From: Danika Cowie
To: Refused@wmawater.com.au
Cc: Garth Nolan
Subject: Request for a fee proposal - Independent third party review of Flood Impact Assessment
Date: Wednesday, 7 June 2017 2:35:00 PM

**Re: Independent Third Party Review of Flood Impact Assessment
Twin Waters West
Proposal for Consulting Services**

Figure 1
Locality Plan
Twin Waters West
Flood Impact Assessment
Stockland Pty Ltd

Structure 10A – Single MIKE culvert represented in TUFLOW as two separate culverts

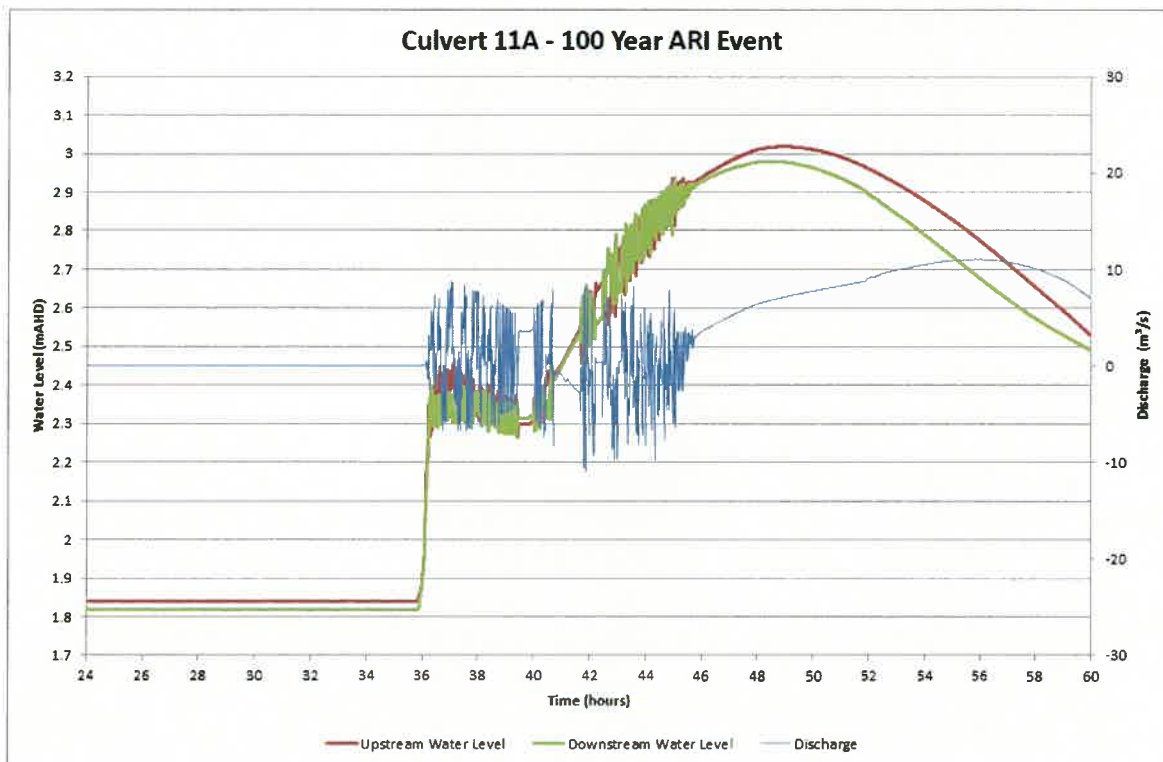
For example, Figure D2 in the WMAwater report shows the discharge hydrograph at Culvert 11A in the 100 year ARI event. This graph is reproduced below, including the water level hydrographs on the upstream and downstream sides of the culvert. The graph demonstrates that the minor instabilities do not affect the calculation of the peak flood level at the structure.

In the TUFLOW model, Structure 10A is located under the Sunshine Motorway, and Structure 10B is located under the off ramp to North Shore Connection Road.

Structure 10A – Single MIKE culvert represented in TUFLOW as two separate culverts

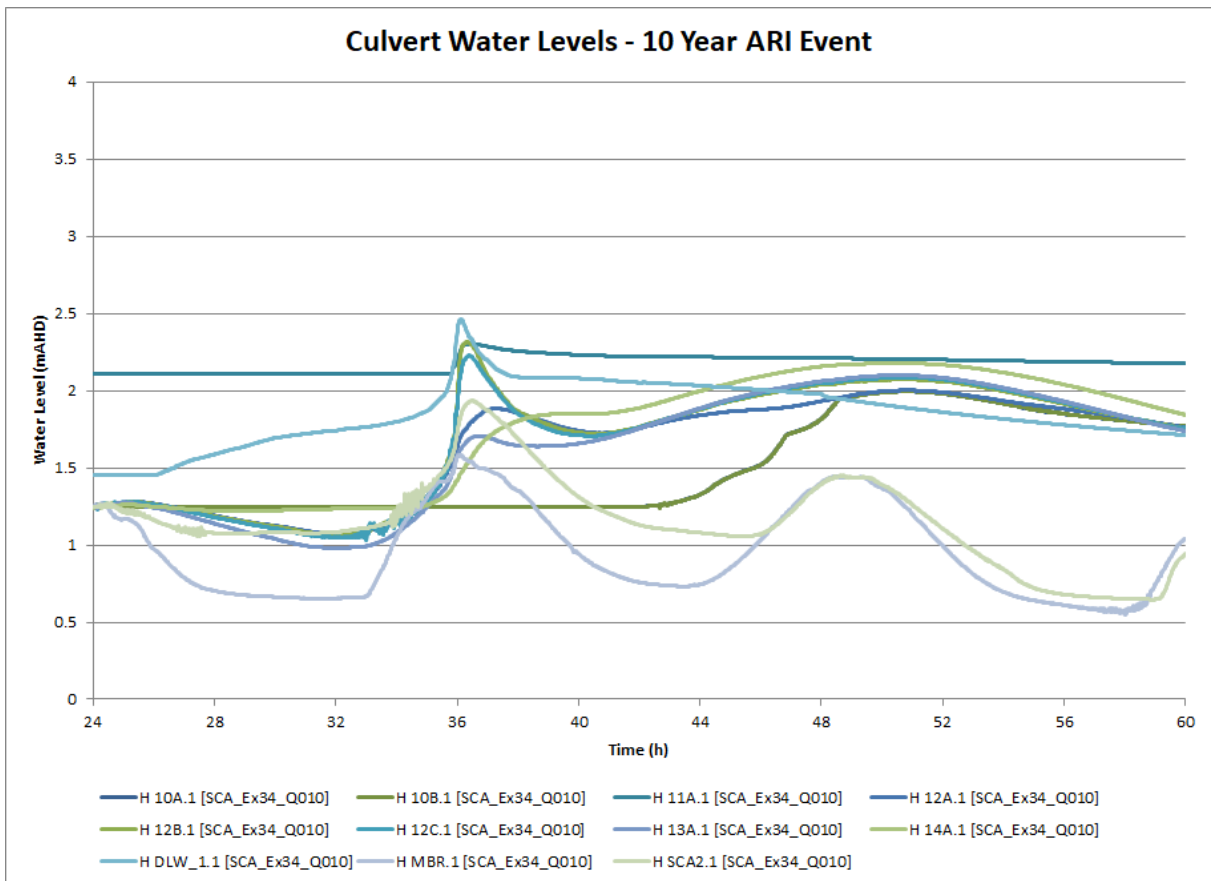
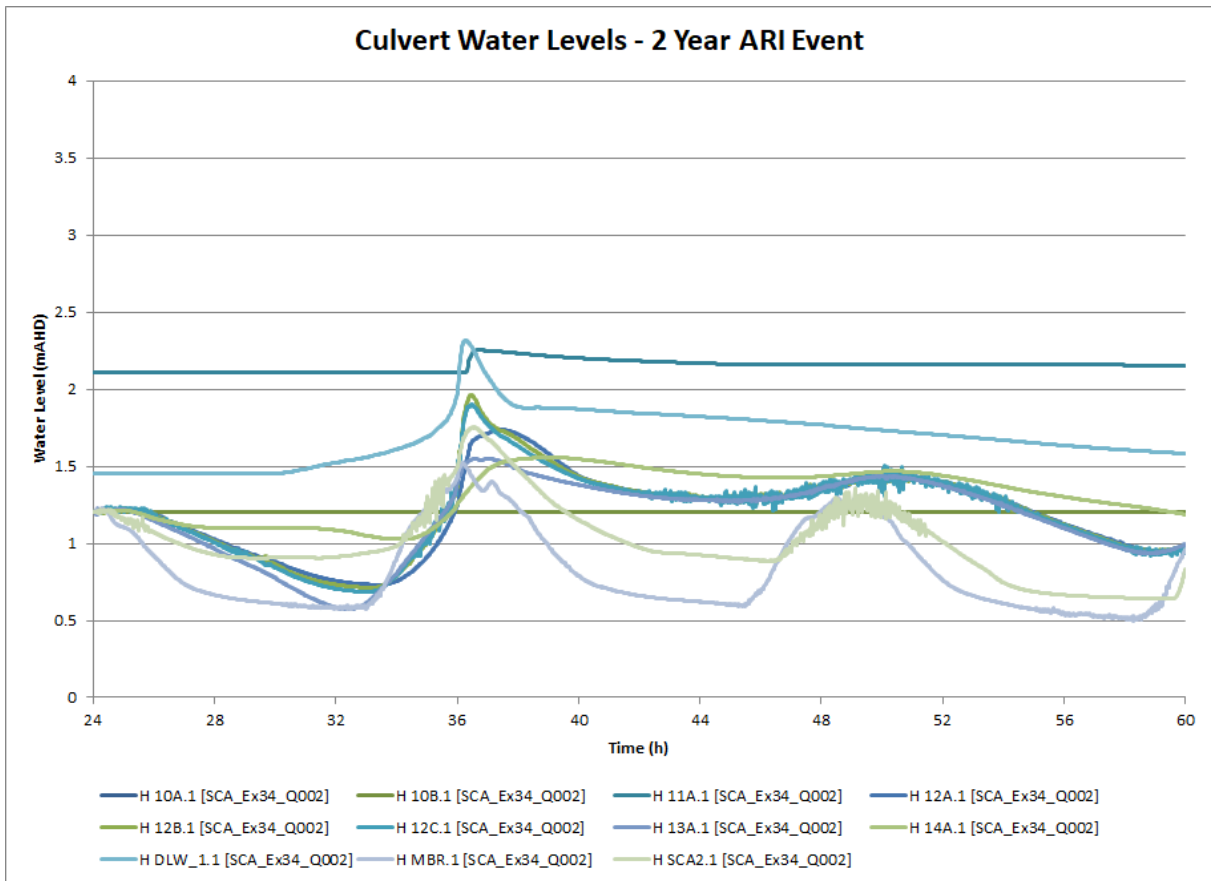
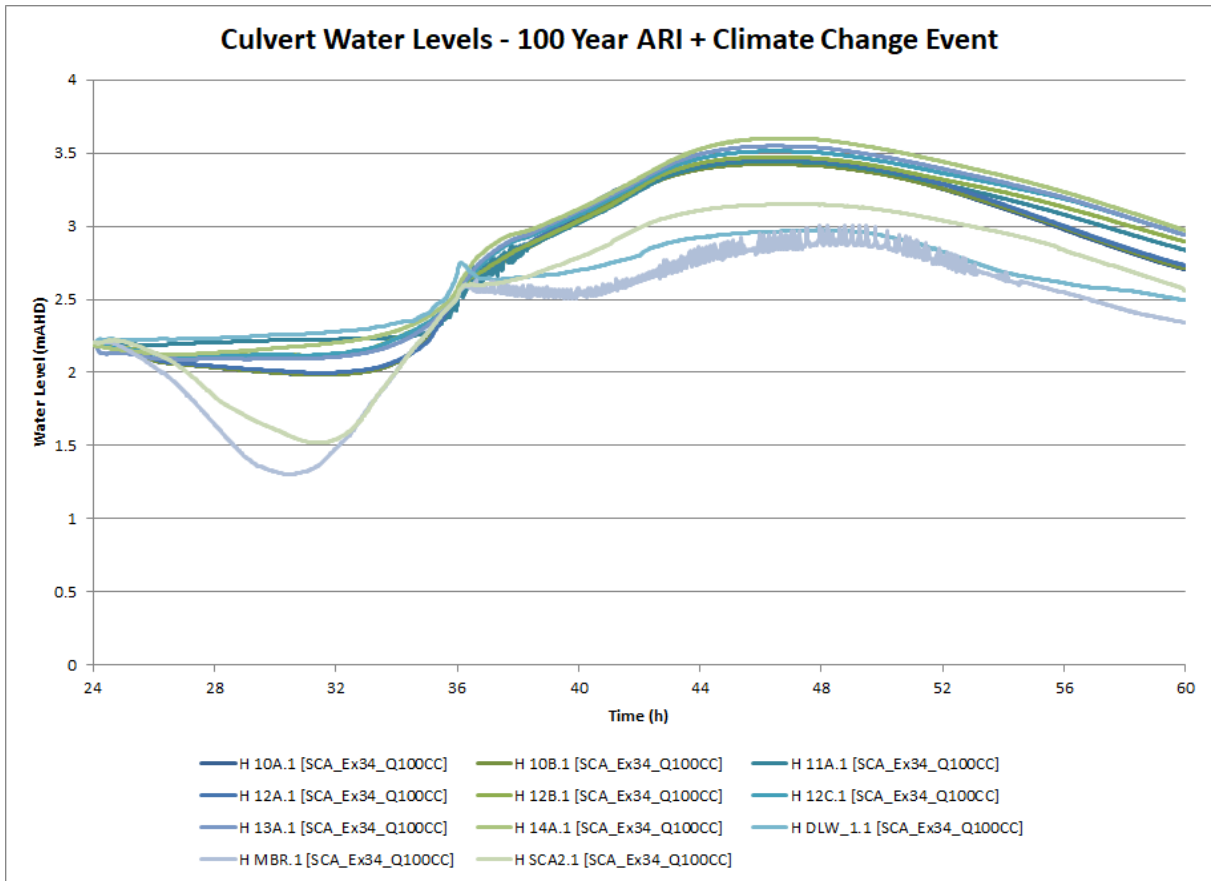
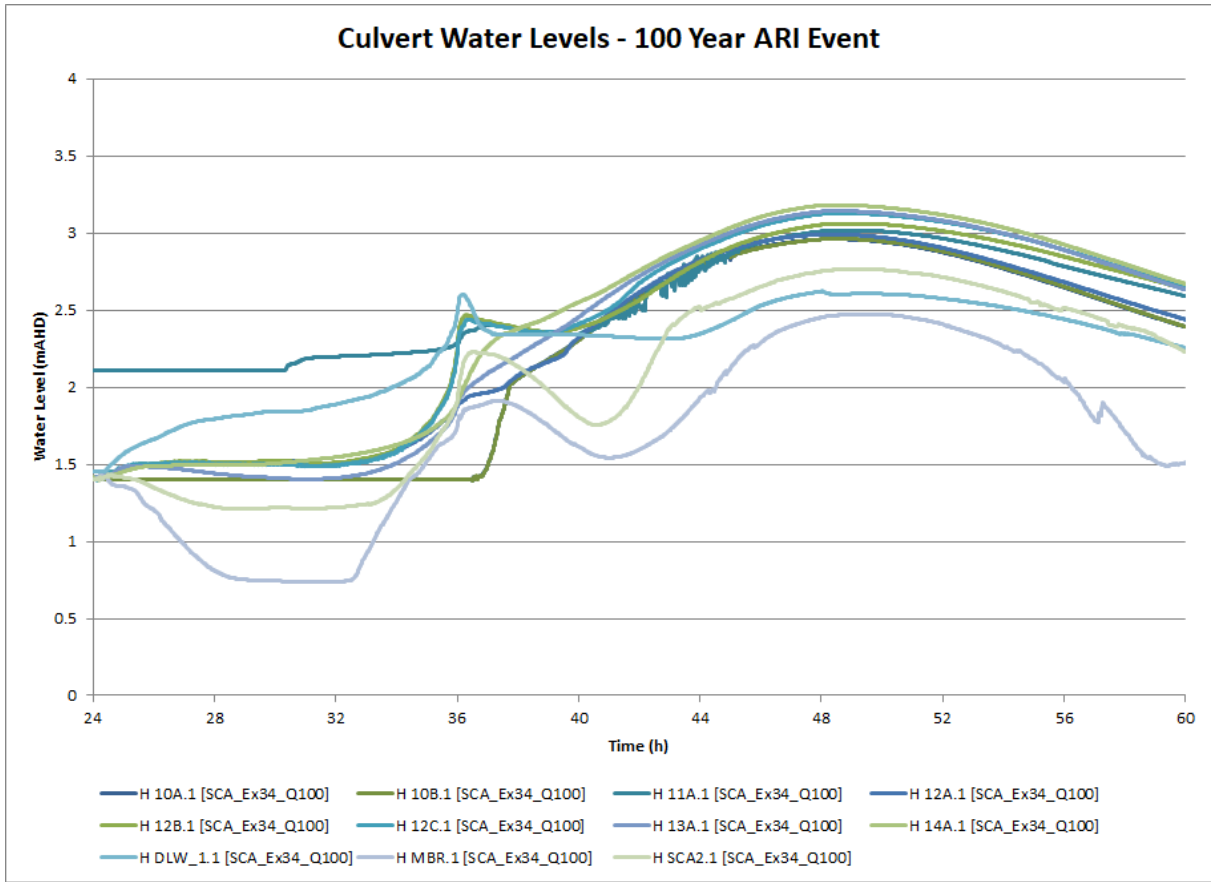
The water level hydrographs on the upstream side of all 1D structures are shown below. These graphs show that there are no significant instabilities in the model. Further results are available from the model output files.

In the TUFLOW model, Structure 10A is located under the Sunshine Motorway, and Structure 10B is located under the off ramp to North Shore Connection Road.

Structure 10A – Single MIKE culvert represented in TUFLOW as two separate culverts

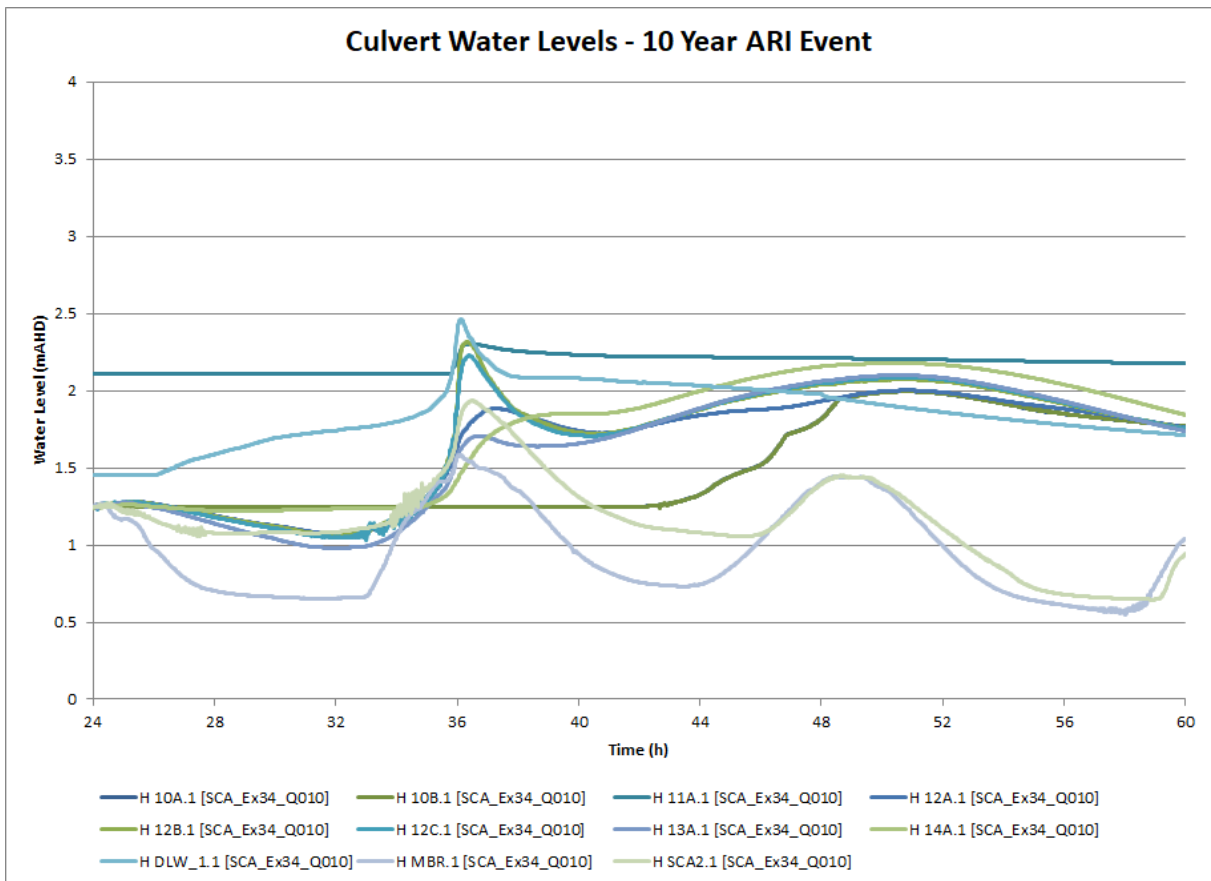
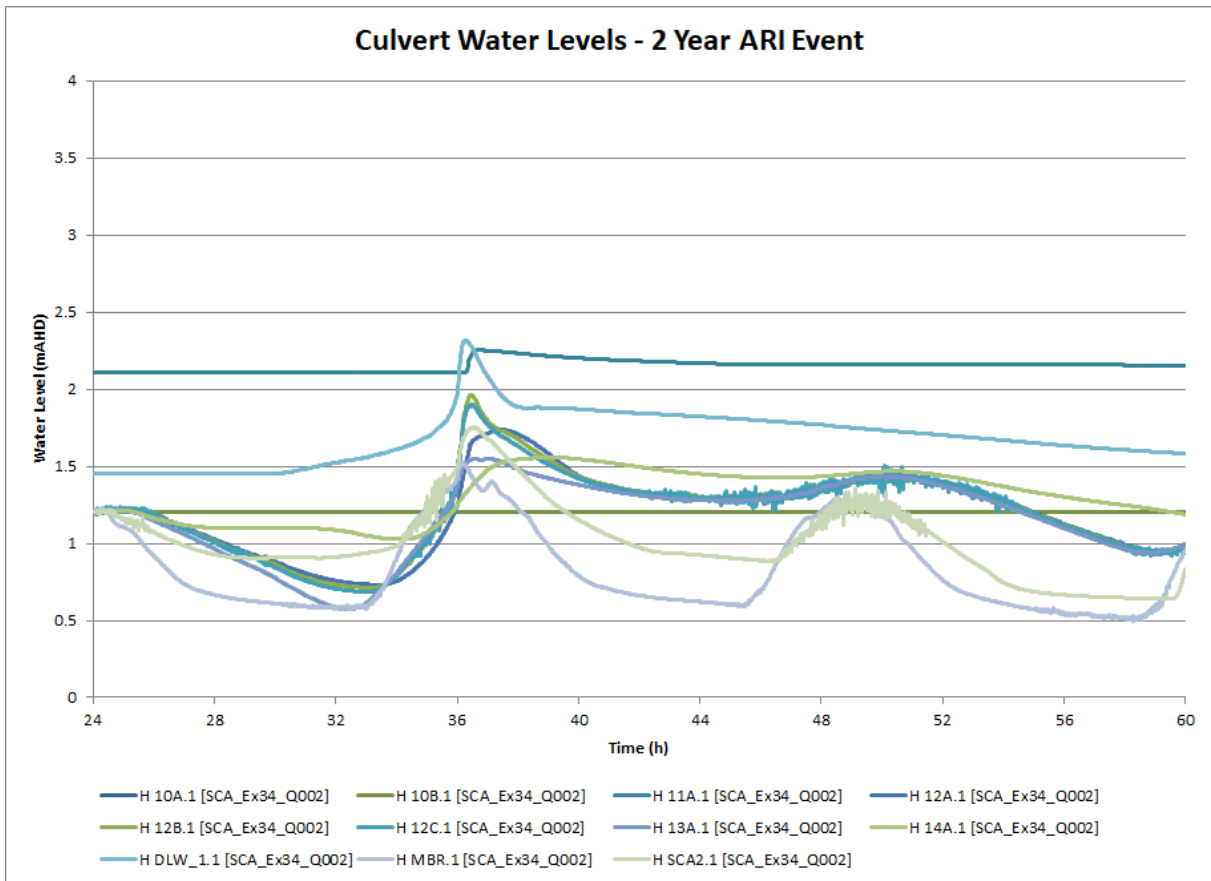
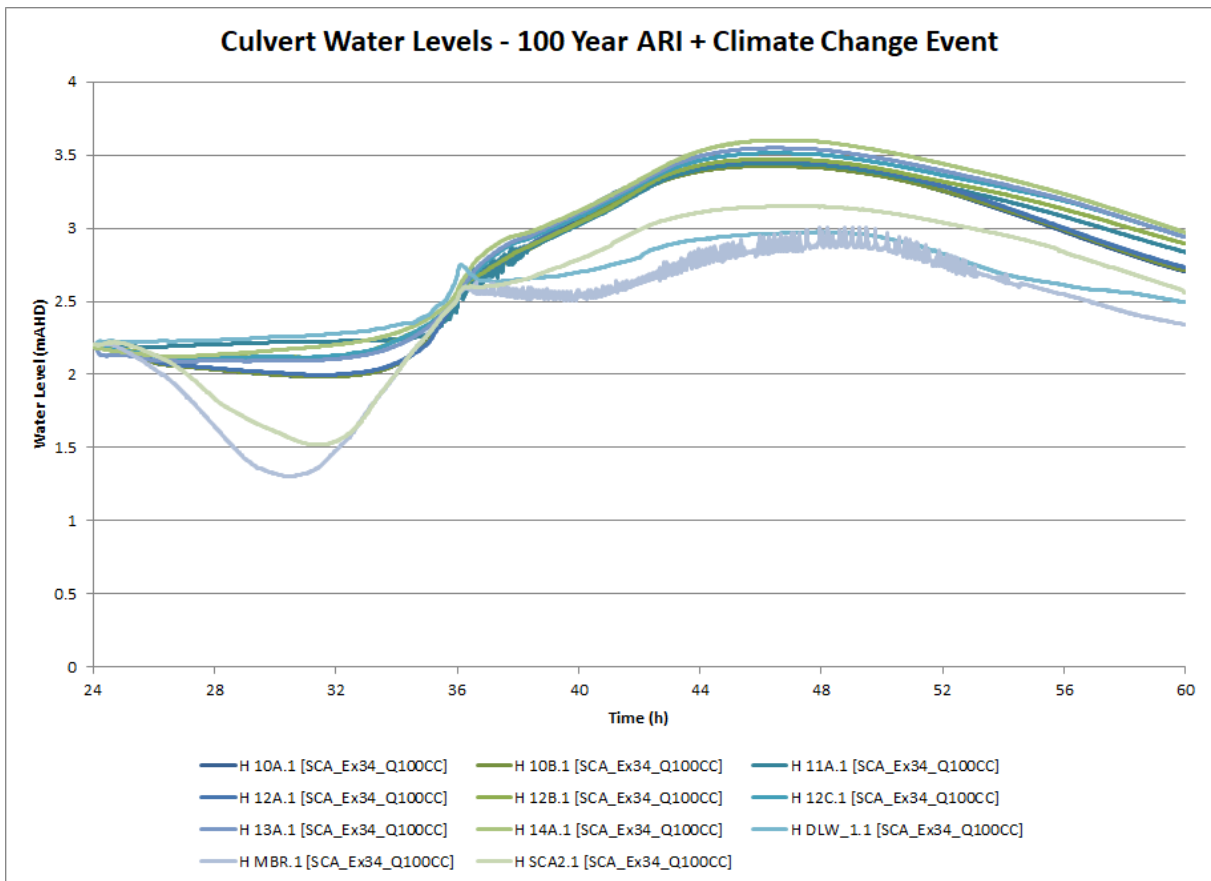
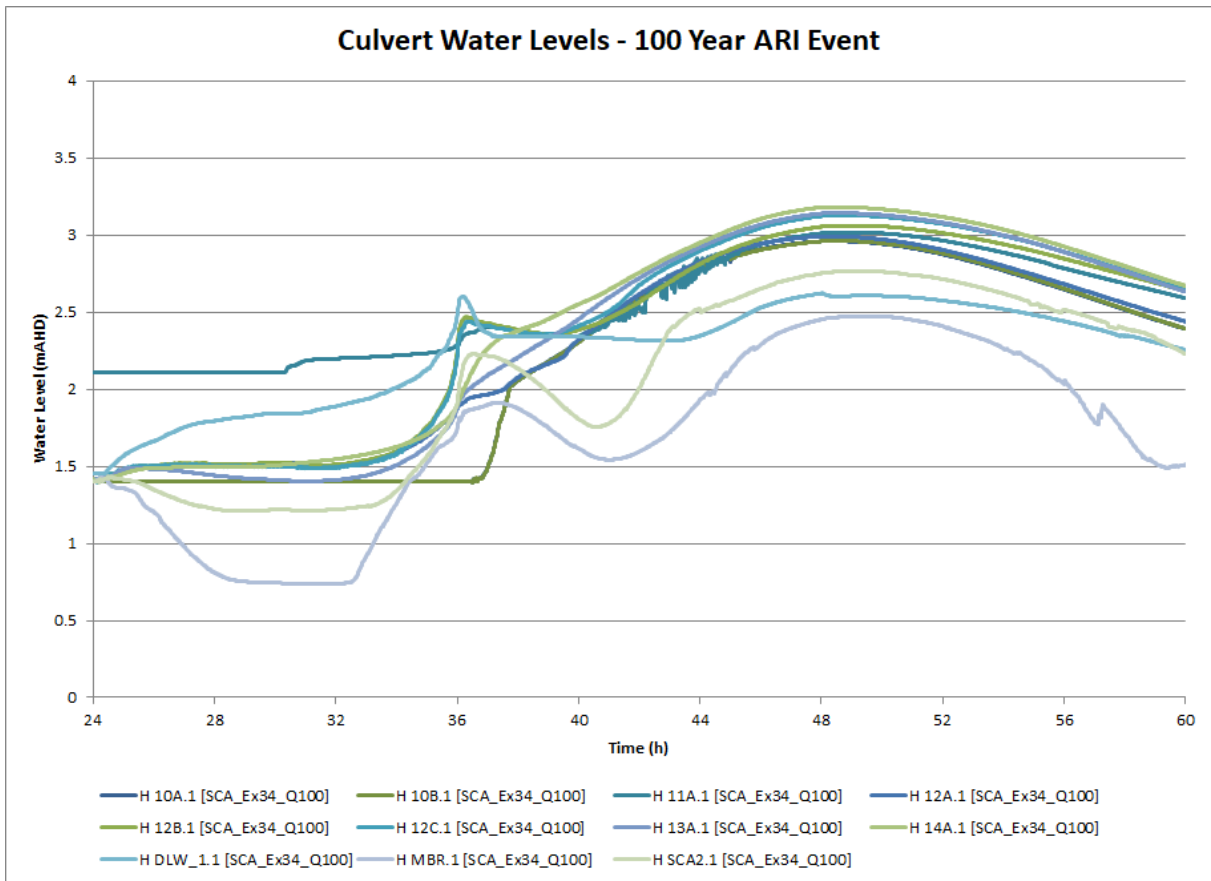
In the TUFLOW model, Structure 10A is located under the Sunshine Motorway, and Structure 10B is located under the off ramp to North Shore Connection Road.
